SHEARON HARRIS NUCLEAR POWER PLANT, UNIT NO. 1
DOCKET NO. 50-400/LICENSE NO. NPF-63

RESPONSE TO THE REQUEST FOR ADDITIONAL INFORMATION CONCERNING
THE LICENSE AMENDMENT REQUEST FOR A ONE-TIME INCREASE IN STEAM
GENERATOR INSPECTION INTERVAL (TAC NO. MC1633)

SHEARON HARRIS NUCLEAR POWER PLANT, UNIT NO. 1
DOCKET NO. 50-400/LICENSE NO. NPF-63
RESPONSE TO THE REQUEST FOR ADDITIONAL INFORMATION CONCERNING THE
LICENSE AMENDMENT REQUEST FOR A ONE-TIME INCREASE IN STEAM
GENERATOR INSPECTION INTERVAL

Figure 1 - W model D75 S/G

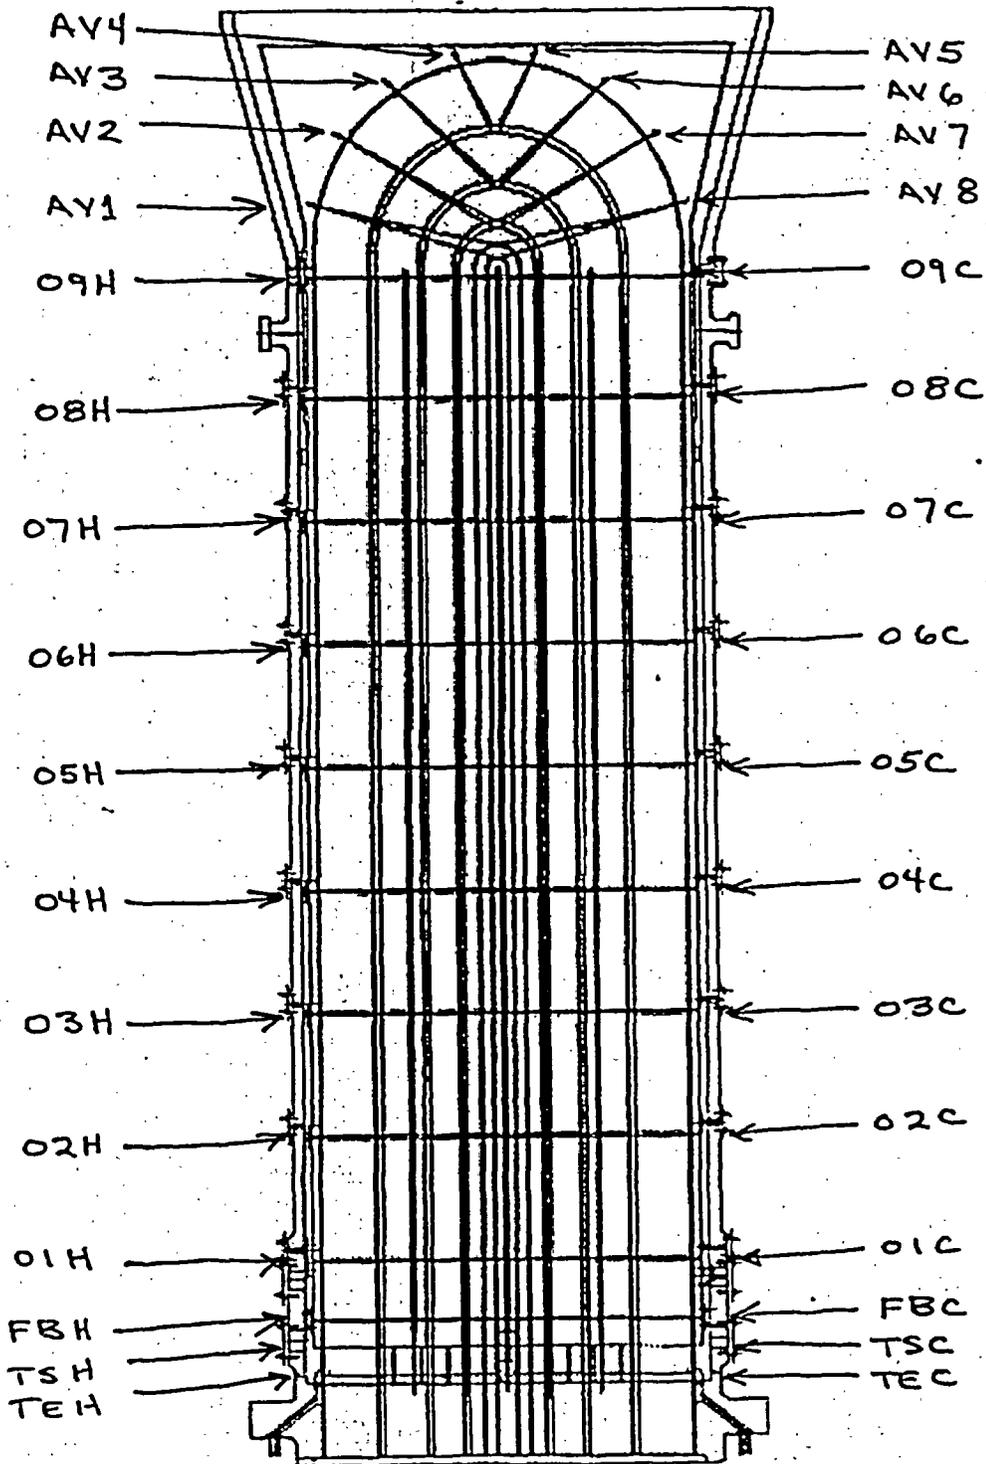
a. Schematic which depicts the tube supports and the tube support naming conventions

Response to Request 5.a
Schematic which depicts the tube supports and the tube support naming conventions
